CITY OF West Linn

Memorandum

Subject: Post-public hearing written testimony for CUP-25-03/DR-25-03/VAR-25-02 (New Drive-Through Car Wash at 18850 Willamette Drive)

| SITE PLAN WILLAMETTE DRIVE STARBUCKS WEST LINN, OREGON | SHEET NO. 1 OF 1 JOB NO. MFX-03 |

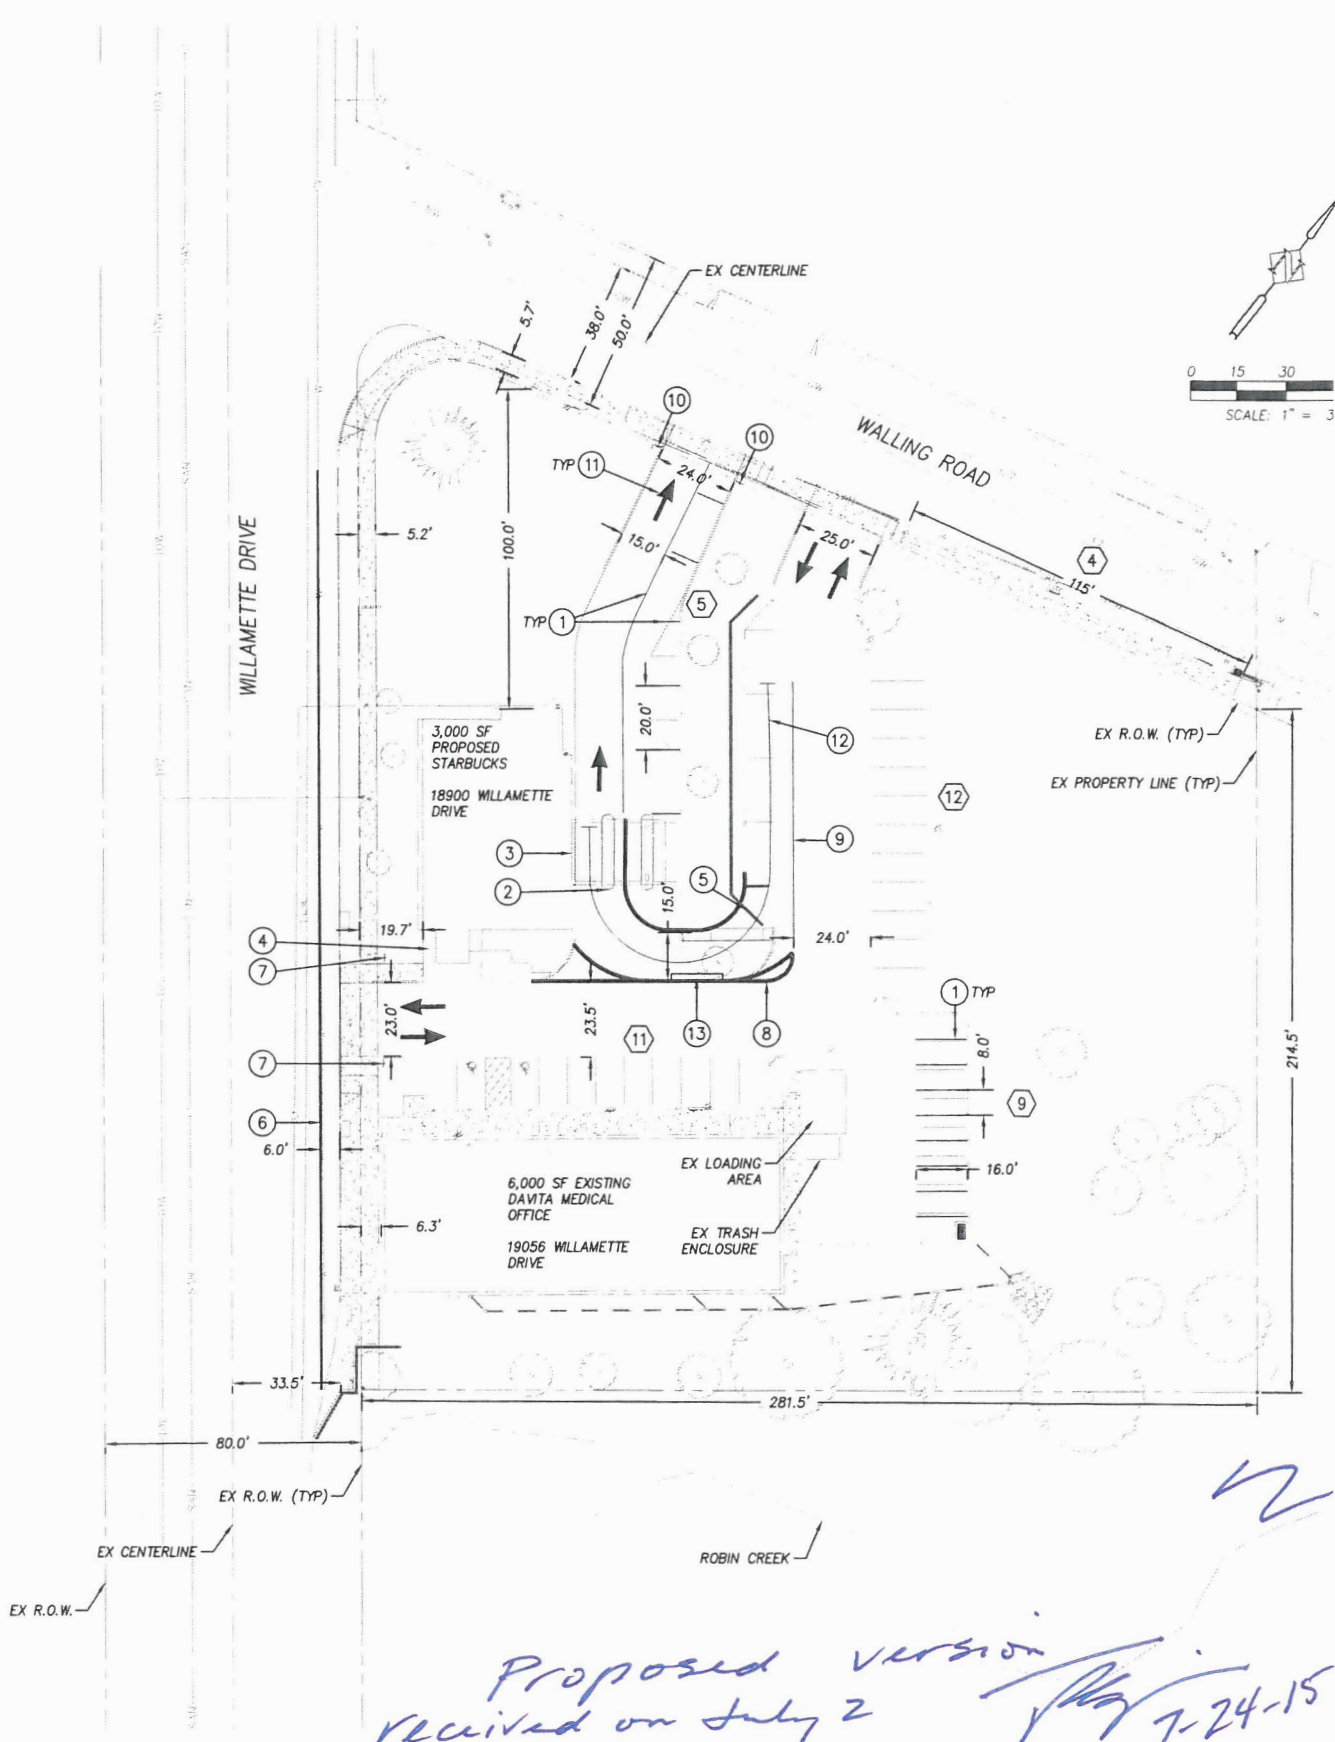
- The Starbucks approved site-plan called for 4 on-street parking spaces on Walling Way to meet the 41 parking spaces required by the city planning manager. See page 7 of the attached Willamette Drive Starbucks Class I Design Review Land-Use Application of July 2, 2015.

- According to that plan: "The applicant agrees to install 5 additional spaces and remove 4 to achieve 36 on-site spaces plus counting 4 on-street spaces on Walling Road..."

- This came about after city associate planner Peter Spir, in a June 25, 2015, email, directed the applicant to relocate four of its required parking spaces "to the area on Walling Drive east of the two way driveway." so Starbucks could accommodate drive through traffic on its site.

- The applicant then "identified on-street parking on Walling Road" to comply with parking dimensional requirements and avoid a variance, according to a July 2, 2015, memo from the applicant's engineer Keith Jones to the city associate planner Spir.

The applicant agrees to install 5 additional spaces and remove 4 to achieve 36 on-site spaces plus counting 4 on-street spaces on Walling Road, as indicated above. However, in the applicant's opinion, the site has adequate parking as is. Many jurisdictions as well as commercial developers and lenders demand a parking ratio of 4 parking spaces per 1,000 square feet of retail. The total square footage of the site has 9,000 square feet and with the existing 36 spaces is consistent with the 4 per 1,000 ratio ($9,000/1,000=9 - 9 \times 4=36$).

SITE PLAN
WILLAMETTE DRIVE STARBUCKS
WEST LINN, OREGON

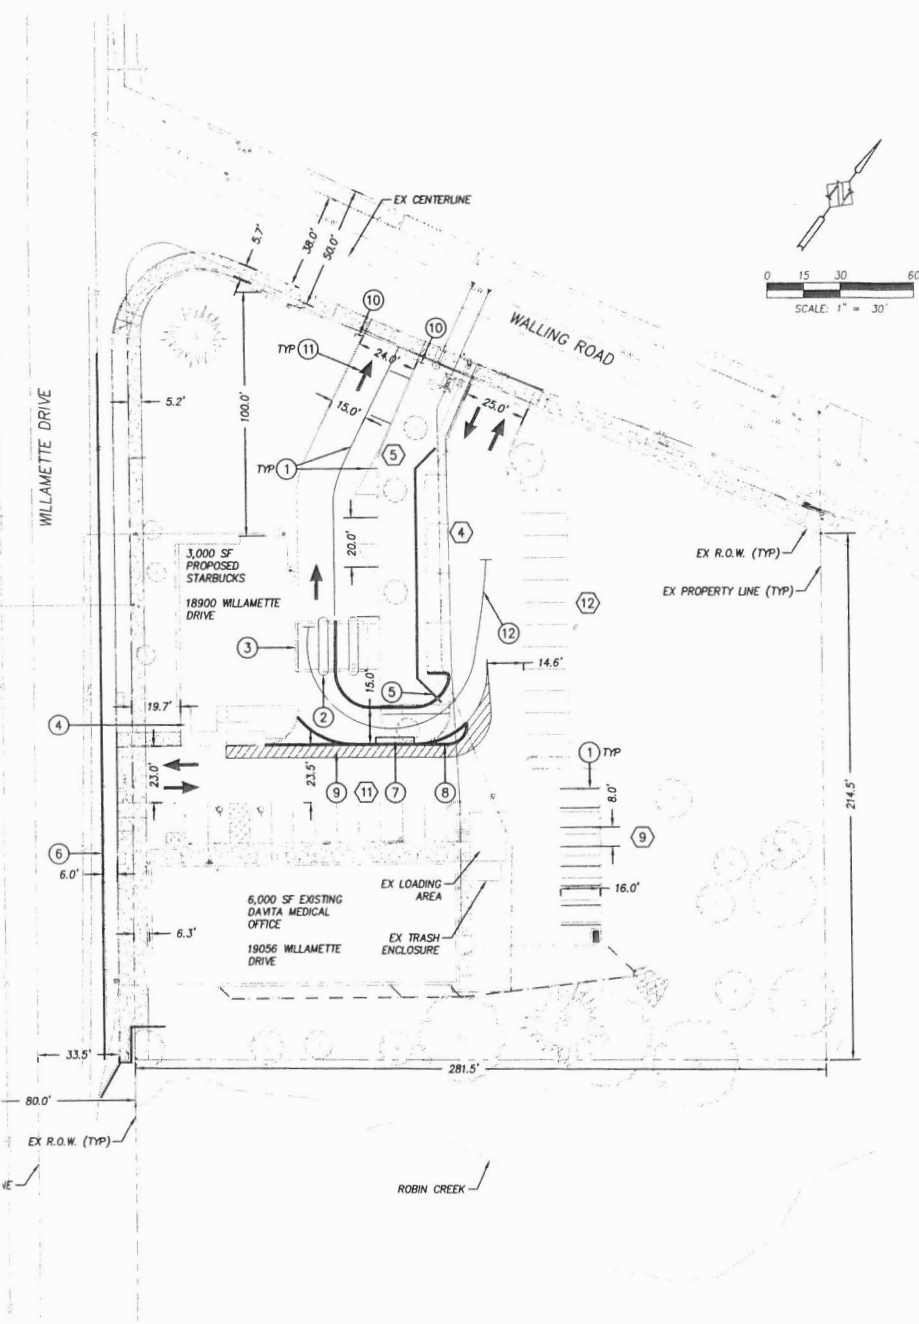
In review of the plans, we do not believe that the proposed parking meets the minimum requirements of the CDC. The applicant has utilized several available mechanisms to reduce the required minimum number of parking stalls from 49 to 41. Regarding these reductions, we do not feel that the proposed uses should qualify for the proposed joint use parking reduction as allowed in 46.050. Although the applicant indicates that they have documented a low number of parking stalls actually utilized for the current medical use, there would be no land use action required to allow a different medical use to move into the facility. It is likely that a new medical user would have a parking need much higher than the current use. In fact, although code requires a 1 space per 250 square feet of medical office space, market generally demands 1 space per 200 square feet for these uses. It should also be noted that the peak parking demands for a medical facility (including the current kidney dialysis clinic), and a Starbucks facility generally occur at the same time and therefore the intent of the joint parking reduction is not met.

It also does not appear that these five stalls meet the dimensional standards indicated for parallel parking stalls. Based on the parallel parking figure provided in chapter 46, only the end stalls can be 20' long, the middle stalls are to be 23' minimum in length. The current plan shows all five stalls at 20' in length, so 9' additional length would need to be provided for these stalls to comply with the dimensional standards.

Based on these concerns, we feel that the applicant should be asked to re-evaluate the proposed design to provide a layout that has suitable parking, safe circulation patterns and minimal impact to traffic congestion on the adjacent roadways.

Response: The applicant has removed the striped crosswalk, moved the drive-thru lane farther west and identified on-street parking on Walling Road. The site now complies with the parking dimensional requirements and a variance is no longer required.
